Joseph Garruba
28 Winchester Dr.
Hollis, NH 03049
August 17, 2020

To: Members of the Hollis Planning Board

Non-compliances of the proposed development of Tax Map 41 Lots 25, 28 and 44 Revision 2

Figure 7 Markup of the developer's alternative conceptual plan submitted on 7/27/2000 with deficient slope modification

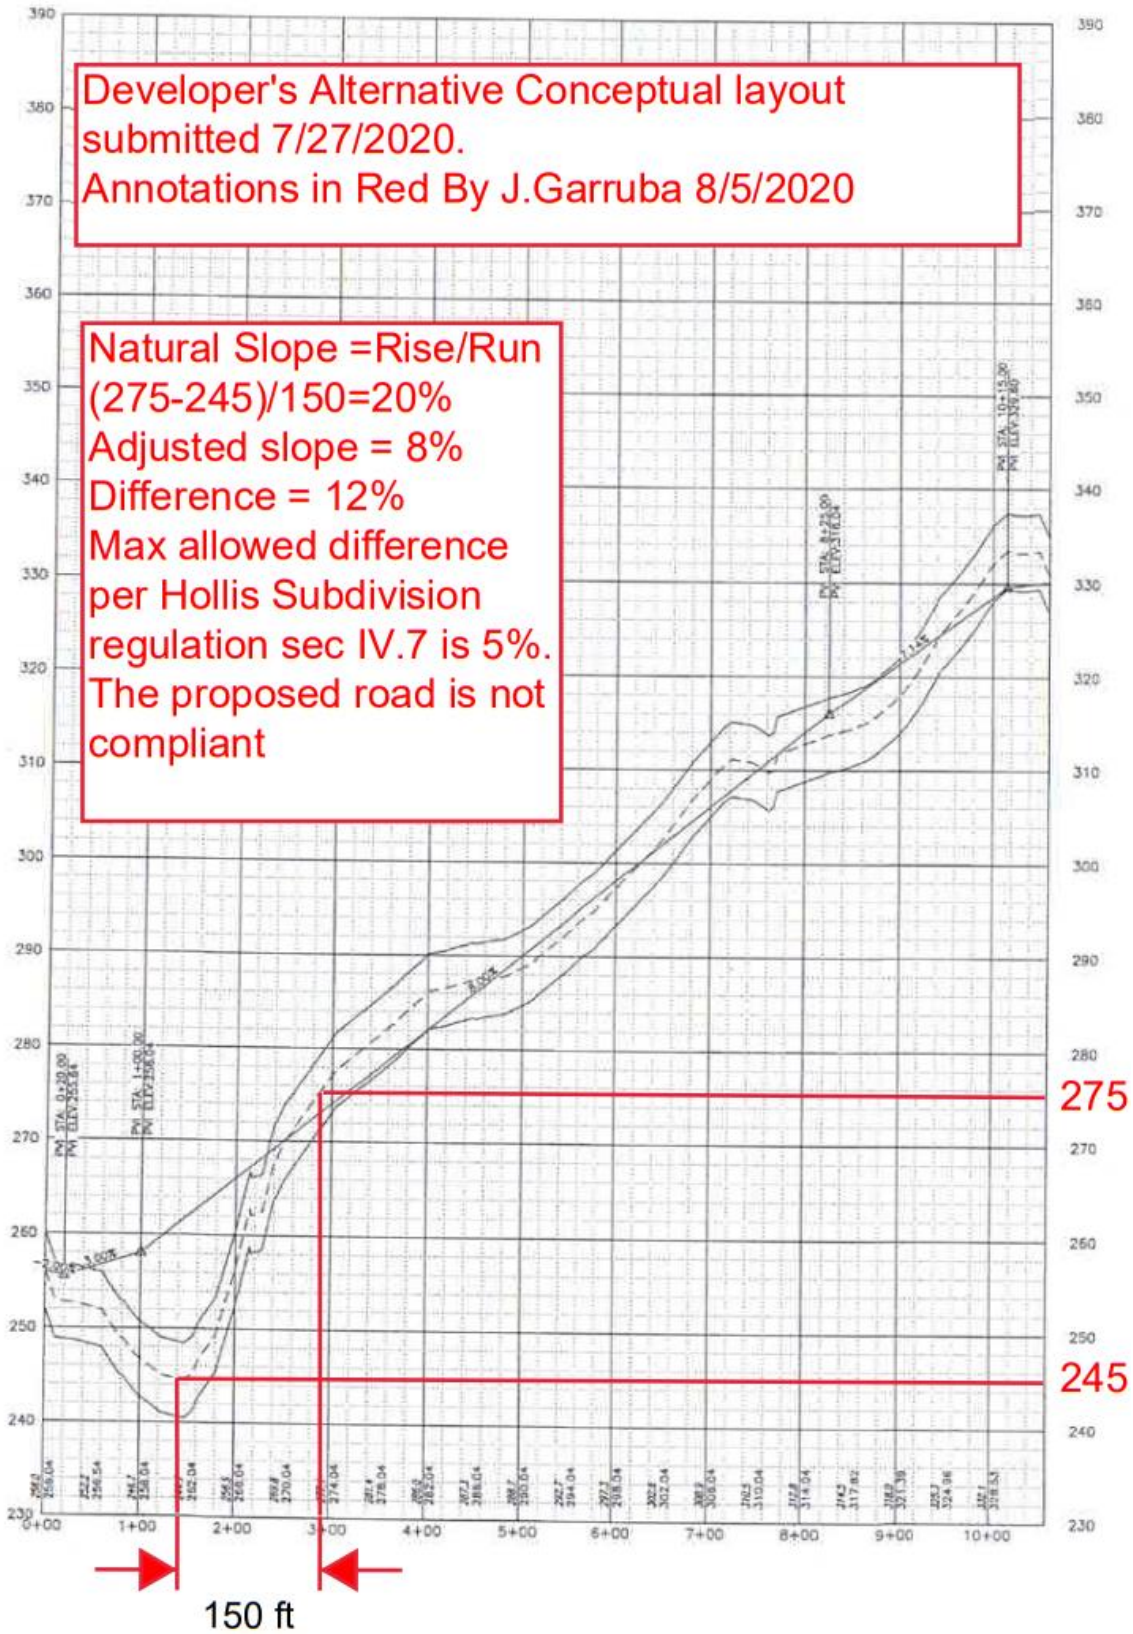
The language of the fourth requirement of Hollis subdivision regulation in section IV.7 is as follows *“In addition, streets and driveways shall not be located where the natural slope of the land, averaged over any 150 foot length, would need to be changed by more than 5 percent in order to achieve the maximum grade standard for new streets or driveways, as applicable”* The information submitted by the applicant does not address this requirement directly and it is difficult from the submitted profile information to make an assessment of this requirement. Using a very basic method from the profile provided shows that the proposed alternative slope is not close to compliant.

The proposed roadway is approximately 3300 ft. long. In order to assess this requirement two sequences of slopes along the outer edges of the required 38-foot-wide road and shoulder are required. These slope points should be taken at 2 foot intervals so that the averages along any 150-foot stretch can be computed and compared against the requirement. I am requesting that the planning board withhold approval of this plan until the developer submits data that will allow the project to be verified against this requirement as written.
